Nº 126 SERVICE BULLETIN

DATE: September 19, 2001

SUBJ: The Bubble Level is back!

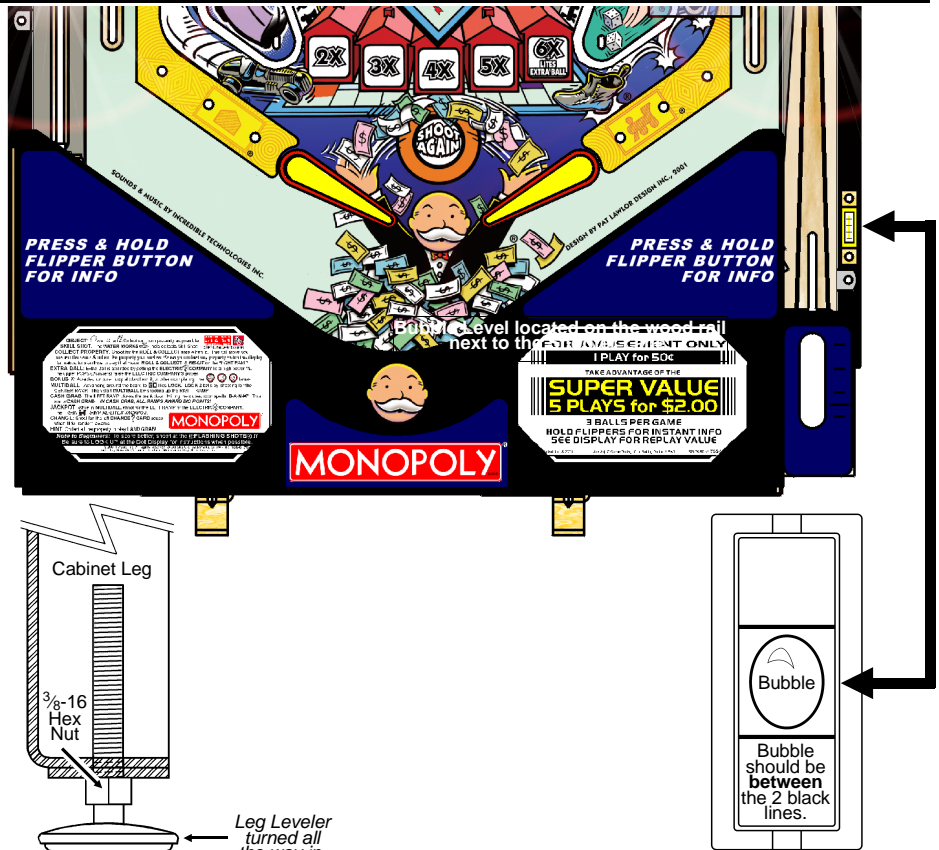
Symptom:

Game play is either too fast or too slow. Pinballs tend to drain quickly or average ball time is high. Game performance is low.

Problem:

Game is not set up properly with the desired 6.5° pitch.

With the bubble level now provided in our games (first included with our current game **MONOPOLY®**), adjustment to the Leg Leveler(s) can now be made accurately.

Start adjustment with the leg levelers *turned all the way in*. **View** the bubble in the level provided on the right side wood rail (see above). **Adjust** the front or rear levelers as necessary to cause the bubble to float between the two (2) black lines. **Note:** For side-to-side leveling, use a pinball to roll down the center of the playfield.

YOUR PLAYFIELD PITCH IS NOW AT 6.5° AS REQUIRED FOR PROPER GAME PLAY!

For custom adjustment greater than >6.5° can be achieved by turning out the rear leg leveler(s), however, **it is not recommended**.
